御中										Issue No. / 発行No: PC-0028782 Issue date / 発行日: 20221213														
<h2 style="text-align: center;">工程変更連絡書</h2> <h3 style="text-align: center;">Process Change Notice</h3>															ヒロセ電機株式会社 東莞工場 品質管理課 Dongguan Factory, Quality control section, Hirose Electric Co., Ltd.									
															承認 (Approval)			査閲 (Review)			作成 (Created by)

ヒロセ電機株式会社 行き To: Hirose Electric Co., Ltd.										Issue No. / 発行No: PC-0028782														
<h3 style="text-align: center;">変更計画可否回答書</h3> Answer to the change plan notification (approval)										製品名 Product name:		DF22-3P-7.92DSA(53)								ご判定日 Judgment day				
										変更内容 Content of change:		金型の更新 / Die/mold replacement								ご担当者 Person in charge				
変更計画可否 Approve or Not approve for the change:										承認 Approved					否認 Not approved					条件付 With condition				
必要提出資料、その他指示事項 Required materials for submission / other directions

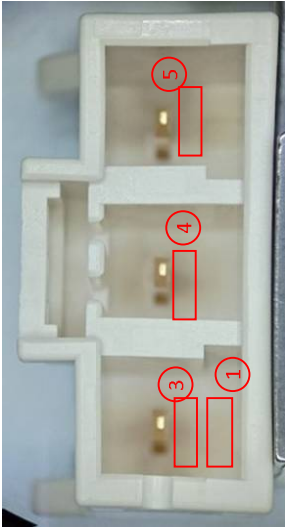
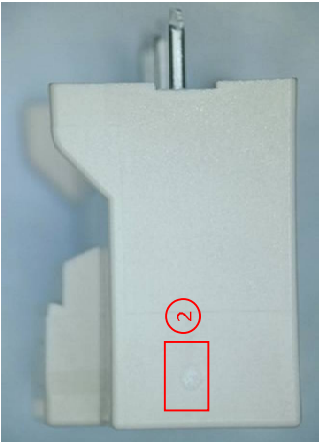
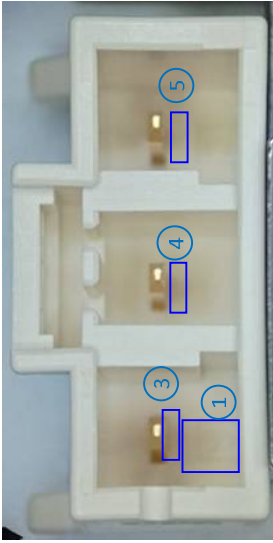
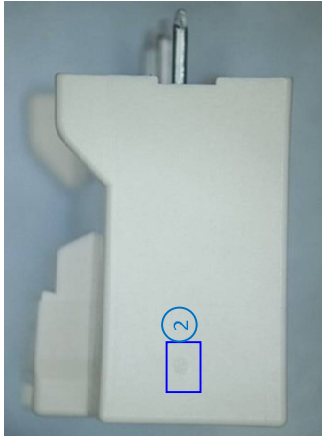
Comparison of DF22					
DF22-3P-7.92DSA (53)		CLN0:680-1015-0-53			
Mold	Difference	①Cavity	②Gate	③ ~ ⑤ Pin mark	
Current	 	 <div> Cavity NO "K、 L、 M、 N" </div>	 <div> Gate diameter is thick </div>	 <div> With pin marks </div>	
Dongguan New	 	 <div> Cavity NO "P、 Q、 R、 S" </div>	 <div> Gate diameter is thin </div>	 <div> Without pin marks </div>
